**1 Products affected**

Product hierarchy no. *			Part no.	SBU	Type / Description	Customer part no.
SBU	PG	PGU	Type			
02	006	019	0000001800	See list below	Power Entry Module with Filter	5003

**2 Type of change**

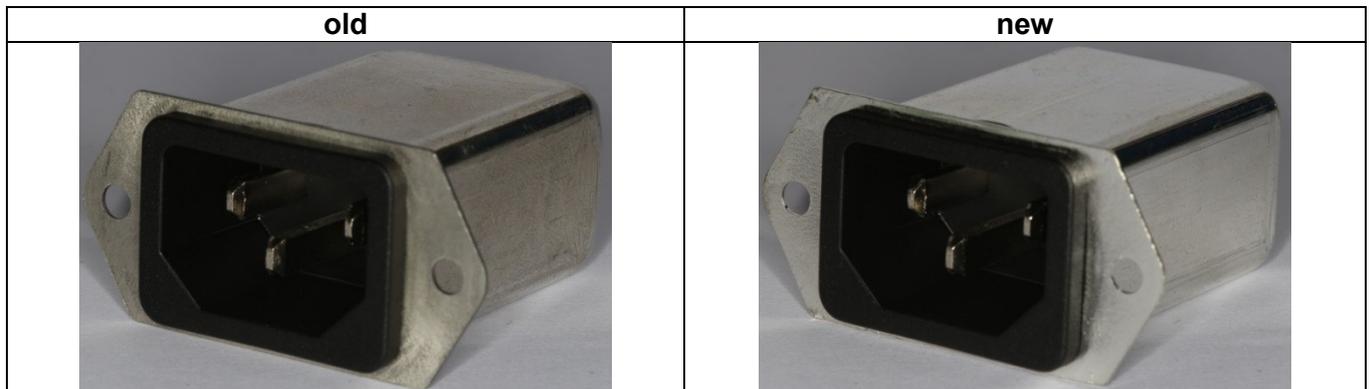
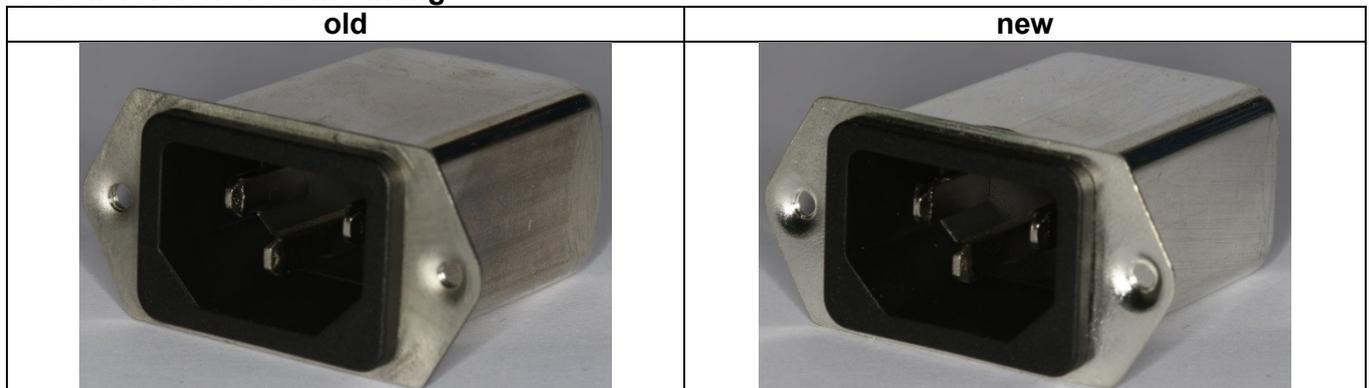
Filter cases for front and rear mounting have a new surface treatment process in order to product improvement.

Surface treatment process of filter case has changed with no change of surface material.

**Screw versions front-side**

**Screw versions rear-mounting**

Form:	No	No change to form but more shiny surface
Fit:	No	There are no dimensional changes
Function:	Yes	Improved resistance against corrosion
Production Site:	No	There is no change of the production site
Product Label:	No	No change to product label
Customer action	No	Notification only
